Access Audit Site Report

Goliad State Park
108 Park Road 6
Goliad, TX 77963
Accessibility Evaluation
Inspection Date: 06/16/2022
Inspectors: Tanya Scheibe

**TEXAS PARKS AND WILDLIFE DEPARTMENT
GOLIAD STATE PARK AND STATE HISTORIC SITE**

**AMERICANS WITH DISABILITIES ACT COMPLIANCE INITIATIVE
PROGRAM AND POLICY REPORT**

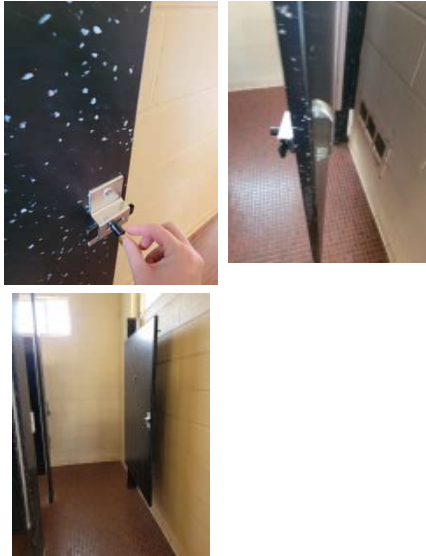
Finding Number	Area Description	Lat/Long	Finding	As Built	Recommendation	Citation	Photos	Figure
224	Camping and Shelters: Screened Shelters	[28.6548565 , -97.386882 1]	An item or items project more than 4 inches into the circulation path. Wall-mounted objects that have leading edges between 27 inches and 80 inches from the floor must not project more than 4 inches into the circulation path. Protruding objects that extend to the floor or within 27 inches of the floor are cane detectable and are therefore not hazardous. Where it is necessary or desirable to have objects protrude from the wall, a manner of cane detection must be provided.	Screened shelter 4 (interior) - 2 of 2 shelves project 7", fire extinguisher projects 7"	Relocate protruding objects or place cane detectable warning or bollard at foot of item.	2015 ABAAS Section: 307.2 2012 TAS Section: 307.2 2010 ADAS Section: 307.2

225	Camping and Shelters: Screened Shelters	[28.6548412 , -97.386880 8]	Picnic tables shall provide at least one wheelchair space for each 24 linear feet (7320 mm) of usable table surface perimeter. Wheelchair spaces shall be 30 inches (760 mm) minimum by 48 inches (1220 mm) minimum. Wheelchair spaces shall be positioned for a forward approach to the table and provide knee and toe clearance complying with 306 under the table	2 of 2 tables (1 inside, 1 outside) are not of an accessible design	Replace picnic tables with ones of an accessible design as a smart practice.	2015 ABAAS Section: 1011.4.2

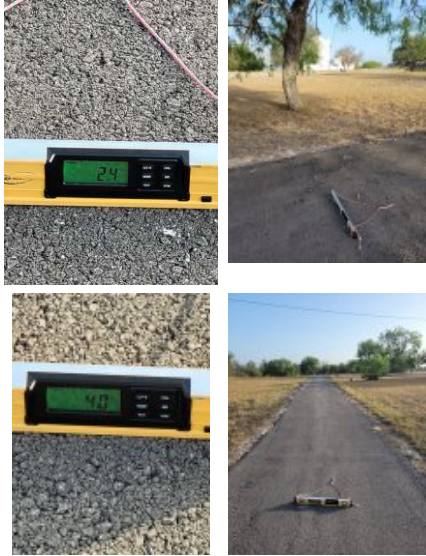
Finding Number	Area Description	Lat/Long	Finding	As Built	Recommendation	Citation	Photos	Figure
239	Camping and Shelters: Men's Restroom - Screened Shelters Camping Area	[28.6550636 , -97.386481 1]	The bench is not deep enough or long enough or is missing. Benches shall be provided having seats that are 42 inches long minimum and 20 inches deep minimum and 24 inches deep maximum. The bench shall provide for back support or shall be affixed to a wall. Back support shall be 42 inches (1065 mm) long minimum and shall extend from a point 2 inches (51 mm) maximum above the seat surface to a point 18 inches (455 mm) minimum above the seat surface. Back support shall be 2½ inches (64 mm) maximum from the rear edge of the seat measured horizontally. The top of the bench seat surface shall be 17 inches (430 mm) minimum and 19 inches (485 mm) maximum above the finish floor or ground. Clear floor or ground space complying with 305 shall be provided and shall be positioned at the end of the bench seat and parallel to the short axis of the bench	Lacks bench in changing area	Acquire and install bench in dressing area having a seat depth of 20" to 24" deep, 42" long, affixed to the wall or having a back and mounted 17" to 19" AFF and provide required clear floor space on the short axis of the bench.	2012 TAS Section: 903.4, 903.2, 903.3, 903.5 2010 ADAS Section: 903.4, 903.2, 903.3, 903.5

240	Camping and Shelters: Men's Restroom - Screened Shelters Camping Area	[28.6550707 , -97.386477 1]	Transfer type shower compartments shall be 36 inches (915 mm) by 36 inches (915 mm) clear inside dimensions measured at the center points of opposing sides and shall have a 36 inch (915 mm) wide minimum entry on the face of the shower compartment. Clearance of 36 inches (915 mm) wide minimum by 48 inches (1220 mm) long minimum measured from the control wall shall be provided.	Shower dimensions are 37" by 37"	Renovate transfer shower to compliant 36" by 36" clear inside dimension.	2015 ABAAS Section: 608.2.1 2012 TAS Section: 608.2.1 2010 ADAS Section: 608.2.1	  	 <small>Note: make required clearance in measured at the center points of opposing sides</small>
